SCIENTIA PROJECT - MONTE SANT ANGELO MERCY COLLEGE (SSD- 10393)

**RESPONSE TO
SUBMISSIONS**

18 August 2020

Figure 4 Elevation Comparison

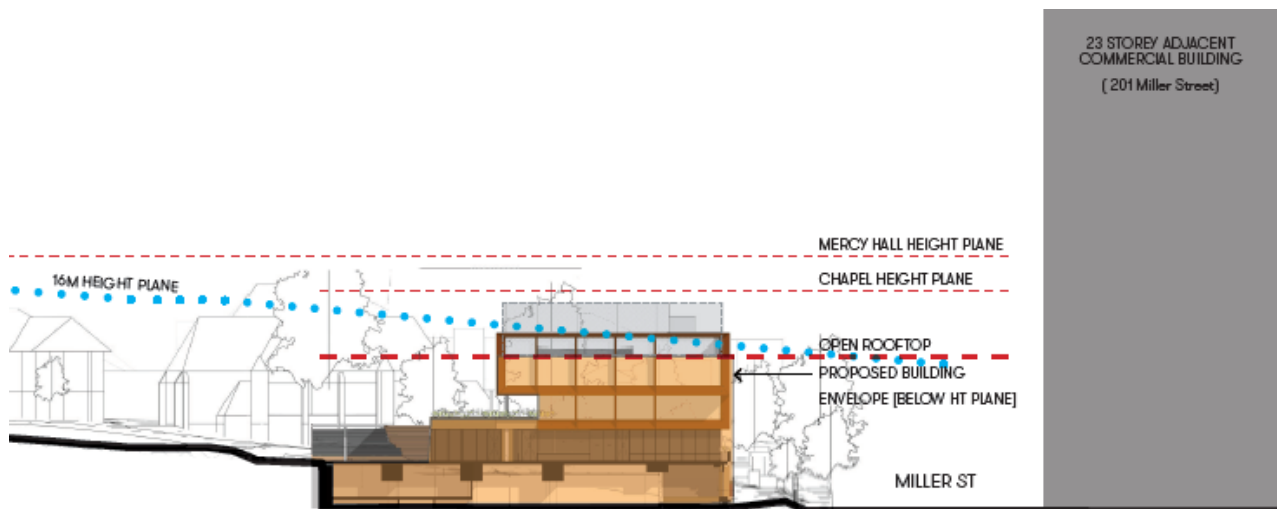
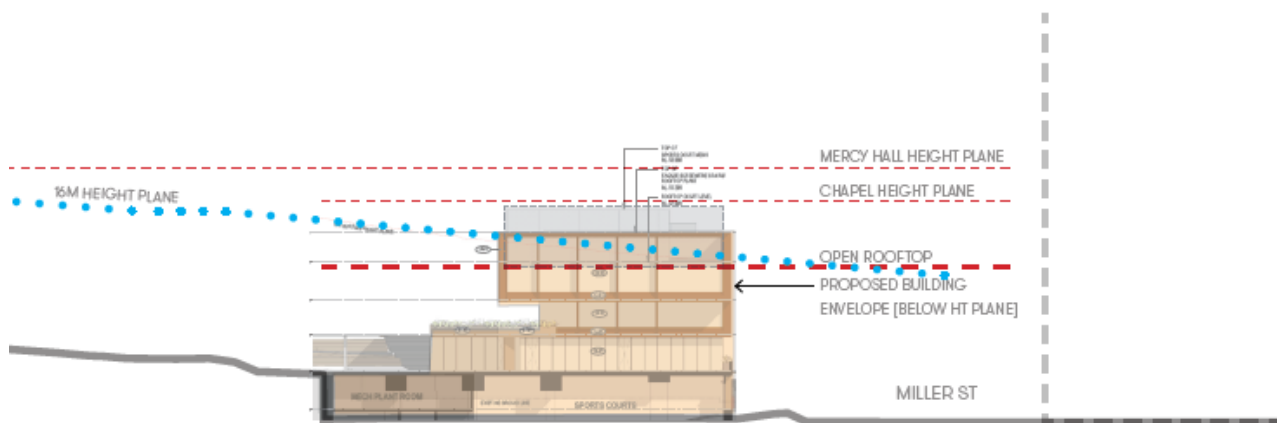
The revised scheme has responded to the request to reduce the height of various building elements (refer to Figure 4):

Original Scheme	Revised Scheme
Maximum height to level 3	16.1m	15.5m
Maximum height to plant room/lift overrun	18.7m	18.1m
Maximum height to façade screen	19.4m	18.6m
Maximum height to the rooftop court mesh fence	21.7m	20.9m

Figure 5 Area of height non-compliance – revised scheme

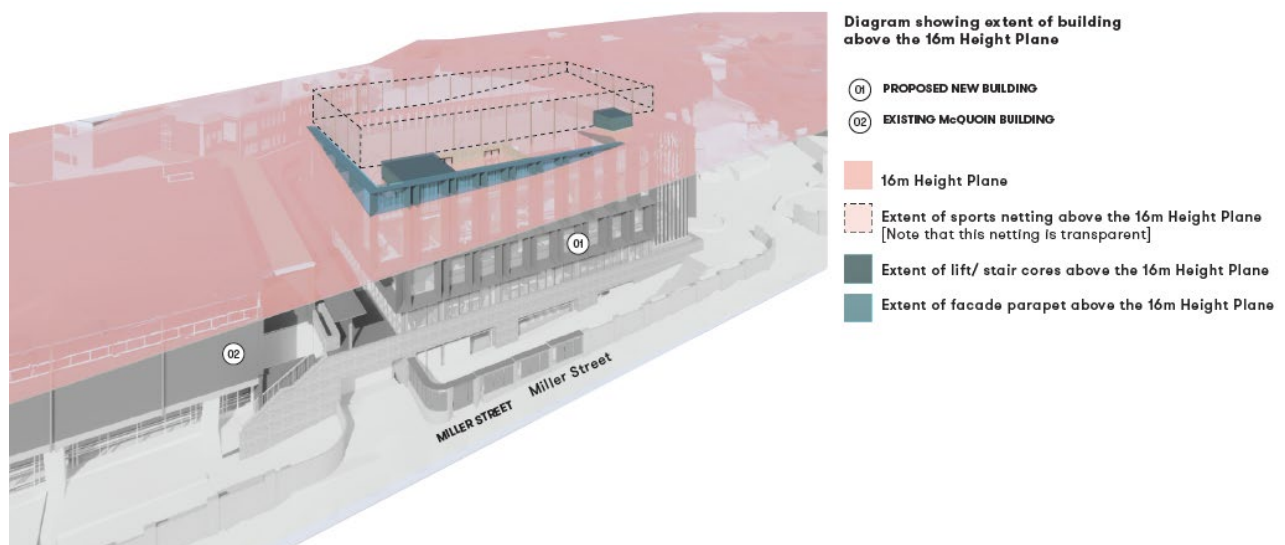
Submission	Comments/Report Reference
North Sydney Council	
<u>Building Height</u> It is recommended that amendments be sought to ensure that the termination of the building top (including faade screen) should comply with the 16m building height control. The proposed additional court fencing should be appropriately set back and should only be supported, subject to consideration of its impacts.	The revised scheme has responded to the request to reduce the height of various building elements (refer to Figure 4): ▪ The floor-to-floor heights to the above-ground science and innovation levels have been reduced, whilst maintaining adequate ceiling heights to ensure a high level of amenity. This has reduced the rooftop court level by 600mm, resulting in the whole rooftop slab level sitting below the 16m building height limit for the site. ▪ The architectural facade screening has also been reduced by 800mm. ▪ Cumulatively, by decreasing floor-to-floor heights and reducing the architectural facade screening the enclosed building area, excluding rooftop court, stairwells and lift core is compliant with the building height control. As the site steeply slopes to the southeast, the following elements exceed the 16m height control (Figure 5): ▪ Facade screen by a small portion at the south east corner of the building. ▪ Lift and stair access ▪ Rooftop mesh fence Section 3.3.1 provides assessment of the proposed variation to the building height control.

As the site steeply slopes to the southeast, the following elements exceed the 16m height control (Figure 5):

- Facade screen by a small portion at the south east corner of the building.
- Lift and stair access
- Rooftop mesh fence

The façade screen element is an architectural roof feature, as it forms part of the architectural design of the building and is a decorative element to the rooftop court. It is not an advertising structure, does not comprise floor space and does not create significant overshadow. Accordingly, the architectural façade screen is consistent with the definition of an ‘Architectural roof feature’ as defined under the North Sydney Local Environmental Plan 2013 (**LEP 2013**) and is considered acceptable and contemplated departure from the building height control.

The area of height non-compliance also relates to the plant room and the lift overrun, which services the building and provides equitable access for students and staff to the rooftop facilities. The plant room is screened by the architectural façade screening, while the lift overrun is further setback from the building façade. Therefore these elements cannot be easily perceived from the street level and do not contribute to the visual bulk and scale of the building.

Figure 6 Revised Shadow Diagram before 3pm

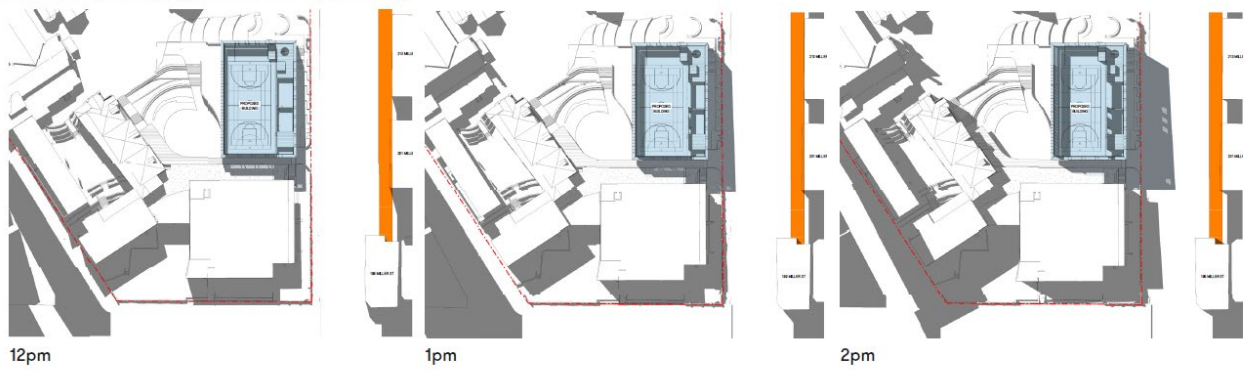
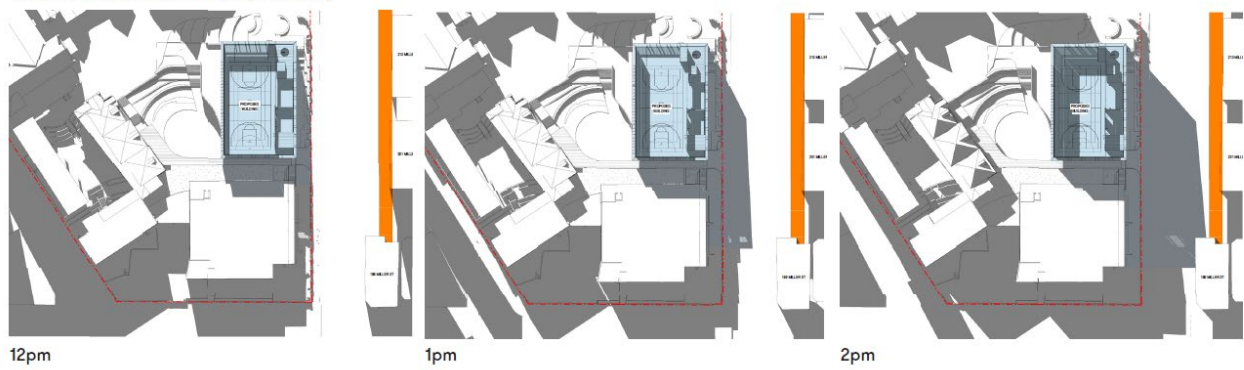
<u>Overshadowing Impacts</u>	Revised shadow diagram has been prepared to demonstrate that the revised scheme, including the rooftop court net will not create net increase in overshadowing to the 'Special Area' between 12 pm and 2 pm from March

Revised shadow diagram has been prepared to demonstrate that the revised scheme, including the rooftop court net will not create net increase in overshadowing to the ‘Special Area’ between 12 pm and 2 pm from March equinox to September equinox (inclusive).

Figure 7 Revised Shadow Diagram after 3pm

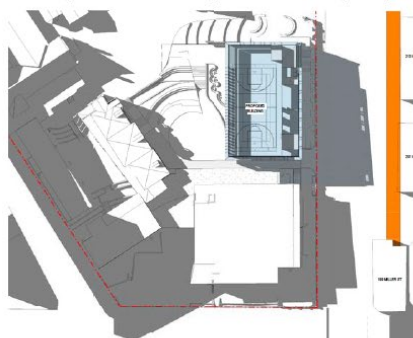
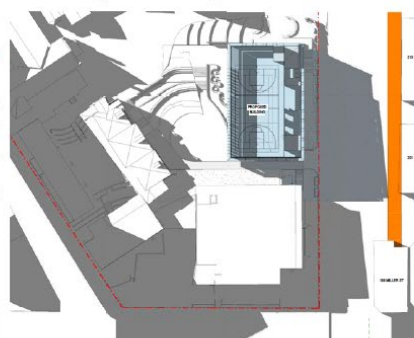
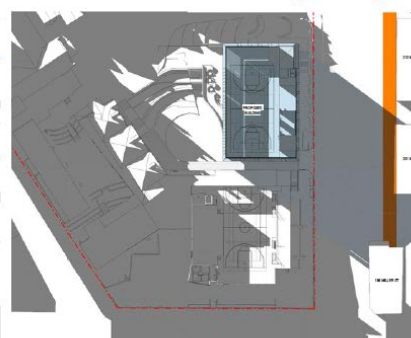
In addition to the LEP provision, as requested by Council in the post exhibition meeting, additional shadow impact have been assessed to demonstrate the impact to the ‘Special Area’ after 3pm. Please note, the assessment has been provided for reference only and it does not change the proposal’s compliance with Clause 6.3 of LEP 2013.

As indicated in Figure 7, the proposed building will not overshadow the ‘Special Area’ at 3pm in March and September Equinoxes. However, it will create additional overshadow to the ‘Special Area’ at 3pm in winter solstice in comparison to the existing shadow from the street trees. Furthermore, it is important to note that a compliant building envelope (16m) would also overshadow the ‘Special Area’ at 3pm in winter. Accordingly, the impact is deemed acceptable and it is outside the compliance requirement of Clause 6.3 of LEP 2013.

Figure 8 Façade Refinement

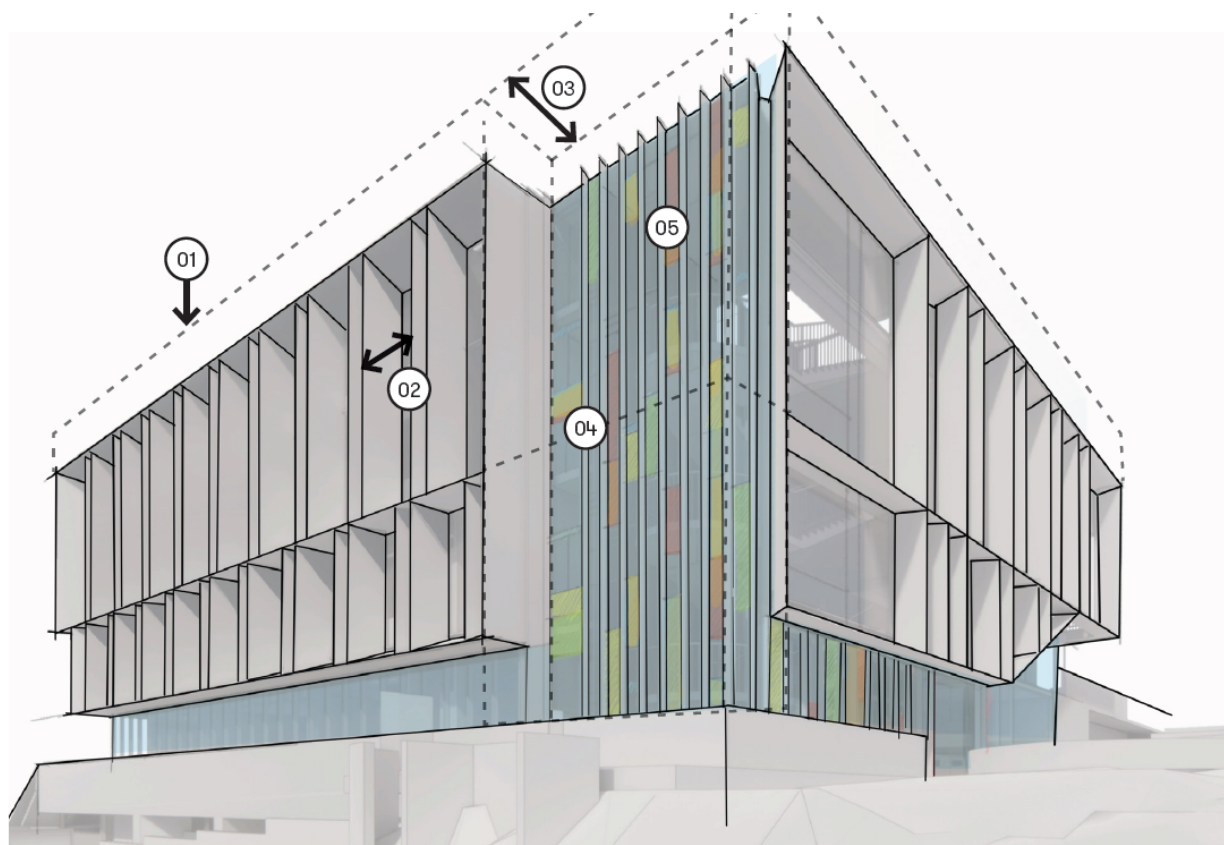
Department of Planning, Industry and Environment	
<u>Built form and Landscaping</u>	
Provide a response and progress update on the revisions and investigations to improve the bulk and scale of the proposed redevelopment. This response must address the following, in particular:	Bulk and scale is discussed in detail in Section 3.3. Passive Solar Design Strategies is discussed in detail in Section 3.7.

In addition to height reduction, the building has been further refined in a number of ways to reduce the bulk and scale of the building, including (refer to Figure 8 and Figure 9):

- Articulation of the facade including the depth, spacing and detailing of the facade fins.
- Further setback of the eastern facade at the north-eastern corner by 2m, signalling the entry and reducing the overall building bulk when viewed from Miller Street (refer to Figure 10).

Figure 12 Key Impact of Setback Increase

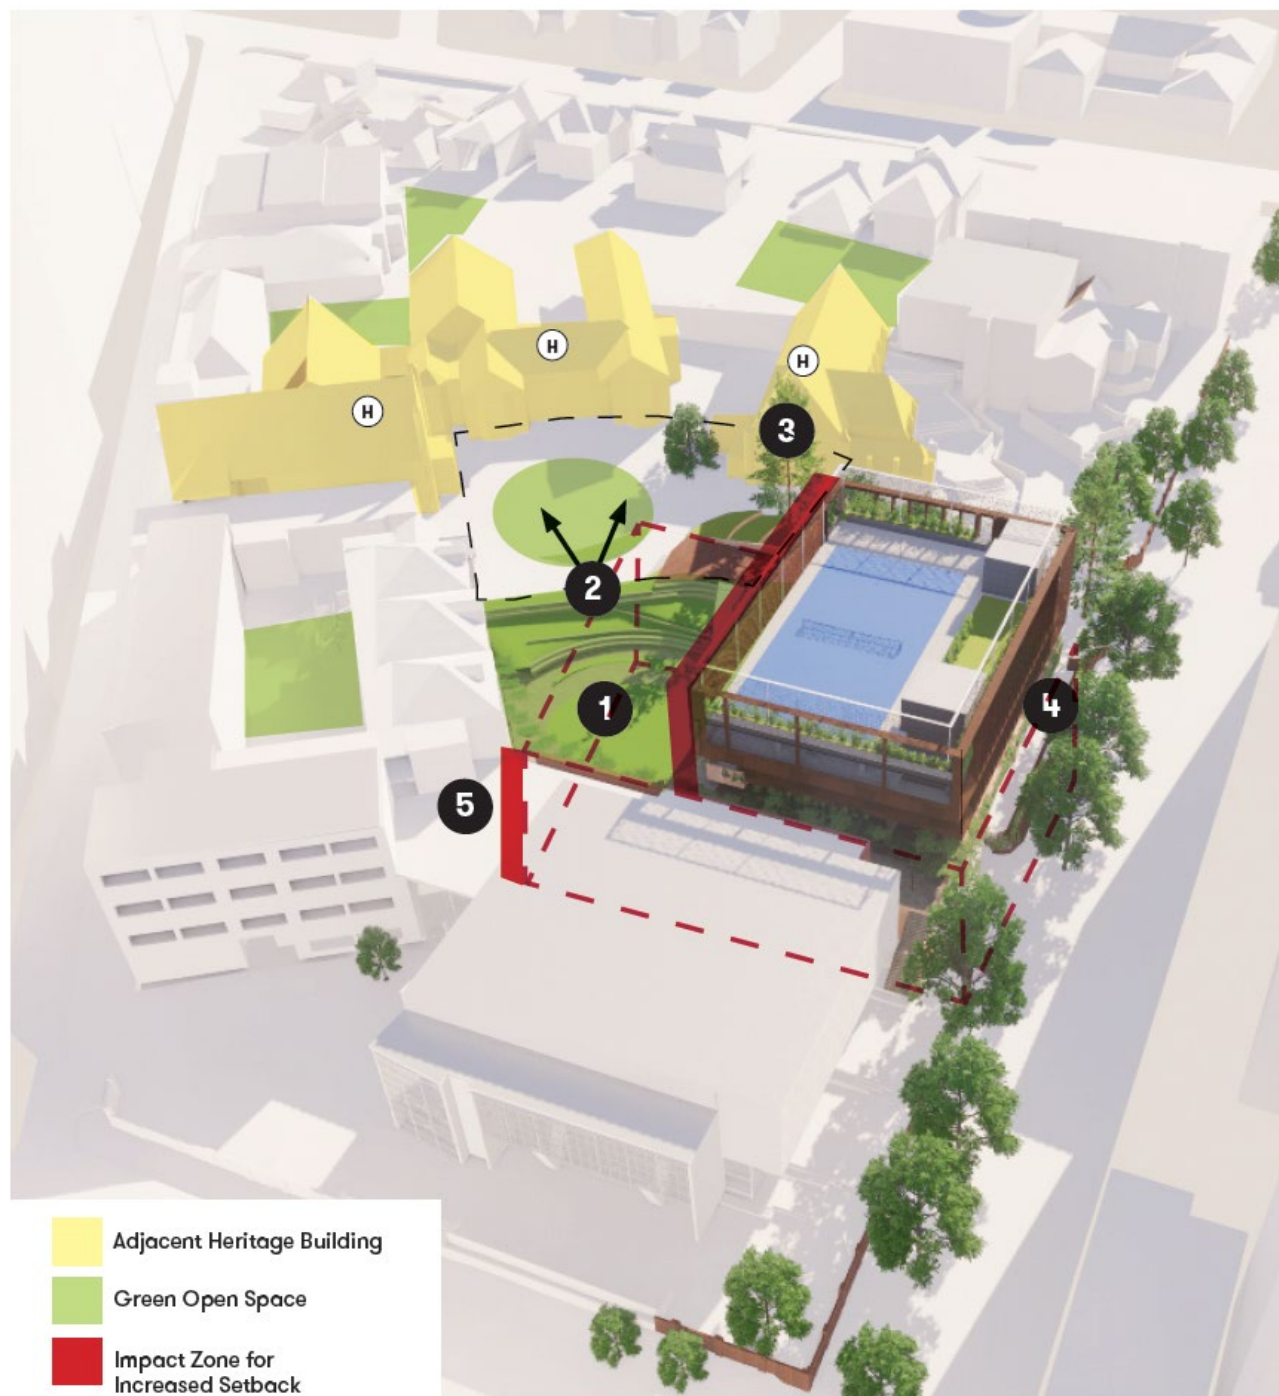
<u>Building setbacks</u> It is recommended that amendments be sought to ensure that the building setback to Miller Street be consistent with the existing setback of the McQuoin Centre, located to the building's south. A deep soil planted buffer zone of trees is provided behind the Miller Street heritage wall. <u>Demolition of Miller Street heritage wall</u> It is noted on the site's Statement of Significance as being an item of heritage significance. Demolition of the wall is therefore, not supported.	The revised scheme has not adopted the additional 1.8m setback (7.8m in total) to Miller Street recommended by North Sydney Council for the reasons discussed in Section 3.4. Whilst the setback of the building is not being increased, the amended design includes a secondary façade setback to the north eastern corner of 2m to minimise visual impact from Miller Street Entrance. It is also important to note that the building is constraint by sports court dimensions, existing trees and the existing College buildings as discussed in Section 3.4. The design team and Monte have taken into consideration of North Sydney Council's recommendation for the retention of the Miller Street boundary wall, and has amended the proposal accordingly to retain the street wall along Miller Street (see Appendix A and Section 3.5).

In summary, the increase setback has not been adopted, as it would negatively impact on the provision of open space, reduce the functionality of the proposed sports and teaching facility and impact on the heritage curtilage. The bulk and scale of the building has been reduced through height reduction, façade refinement and retention of the heritage boundary wall, which are much more effective and positive improvement to the street presentation along Miller Street.

Figure 13 Street Wall Treatment Comparison

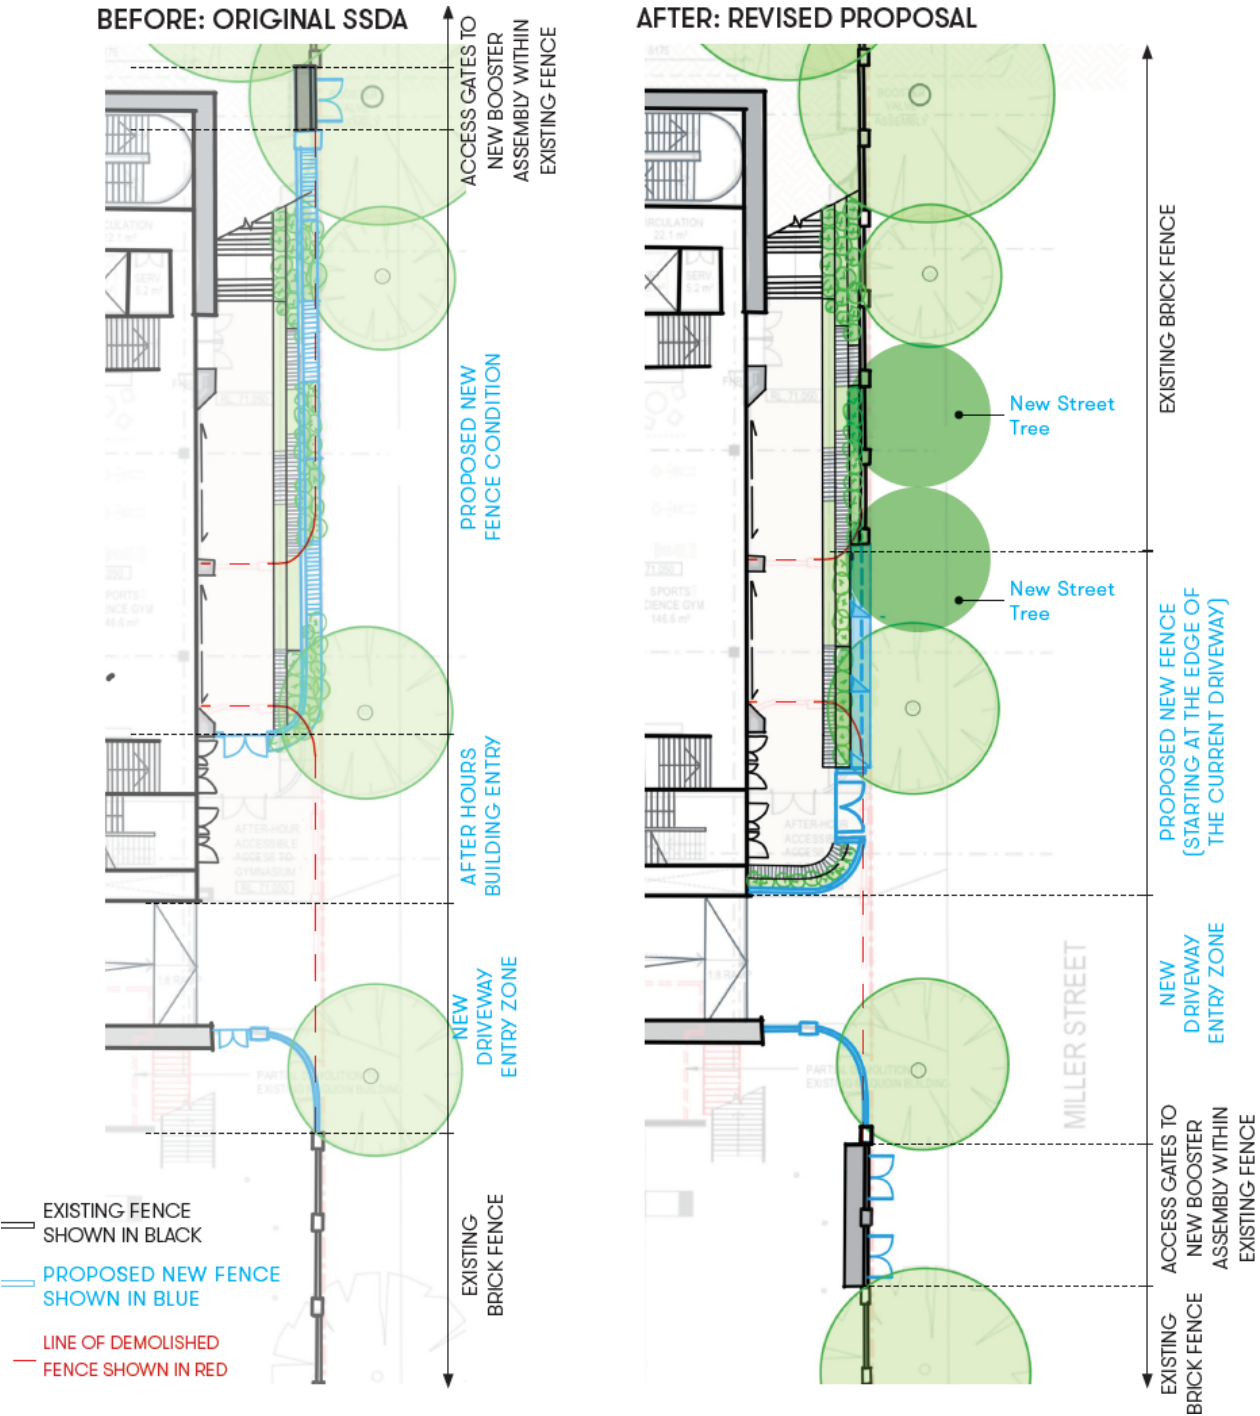
Submission	Comments/Report Reference
It is recommended that amendments be sought to retain the existing heritage brick wall.	The revised design retains the existing brick wall that is currently located along the Miller Street frontage, and only demolish a small portion of the wall for the new car park driveway entry. It should be noted that there is no brick wall at the existing car park driveway entrance. Consequently, there is a small portion of new wall required to connect the retained wall with the proposed driveway entry (refer to Figure 14). Given that this portion of the boundary wall cannot and should not be replicated, the new boundary wall element will be complementary to the existing wall, through matching the height, stepped modulation, alignment and general form. This is consistent with the principles of the Burra Charter, and will assist to retain the importance and significance of the original wall fabric. This design approach is further supported by a Heritage RtS report prepared by NBRS & Partners and attached at Appendix E and discussed in Section 5.

The design team and Monte have taken into consideration of North Sydney Council's recommendation for the retention of the Miller Street boundary wall, and has amended the proposal accordingly to retain the street wall along Miller Street (see Figure 13).

Figure 16 Revised Landscape Treatment along Miller Street

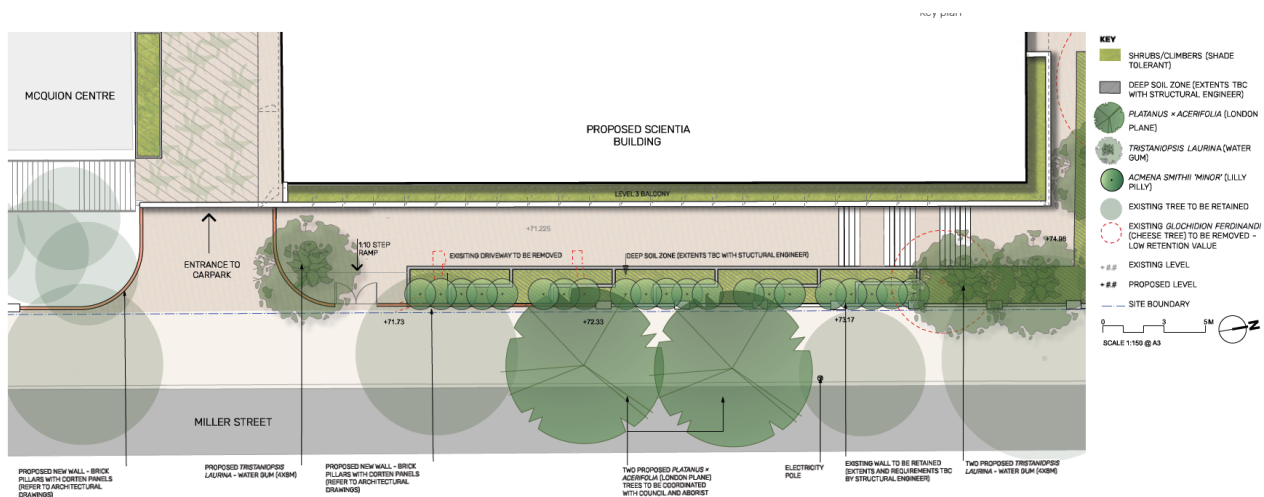
<u>Landscaping within building setback</u> It is recommended that the amendments be sought to provide additional landscaping, including canopy trees, within the setback between the proposed new building and the Miller Street heritage boundary wall.	Landscape is discussed in Section 4. Additional trees have been proposed within the street setback and two additional street trees have been proposed along Miller Street (refer to Figure 16): ▪ Three Tristaniopsis Laurina (Water Gum) located within the front setback, which will further partially screen the building from Miller Street. ▪ Two Platanus × acerifolia (London Plane) street trees located between the pedestrian pathway and the brick wall. These street tree will help screen the new building and continue the existing landscape character along Miller Street (to be coordinated with North Sydney Council and Arborist). Revised Landscape Plans are attached at Appendix C. Accordingly, consistent with North Sydney Council recommendation, the revised landscape treatment along the front setback is able to screen the building and the additional street trees can further complement the Miller

Notwithstanding, to address North Sydney Council and DPIE's post exhibition recommendation, additional trees have been proposed within the street setback and two additional street trees have been proposed along Miller Street (refer to Figure 16):

- Three *Tristaniopsis Laurina* (Water Gum) located within the front setback, which will further partially screen the building from Miller Street.
- Two *Platanus × acerifolia* (London Plane) street trees located between the pedestrian pathway and the brick wall. These street tree will help screen the new building and continue the existing landscape character along Miller Street (to be coordinated with North Sydney Council and Arborist).
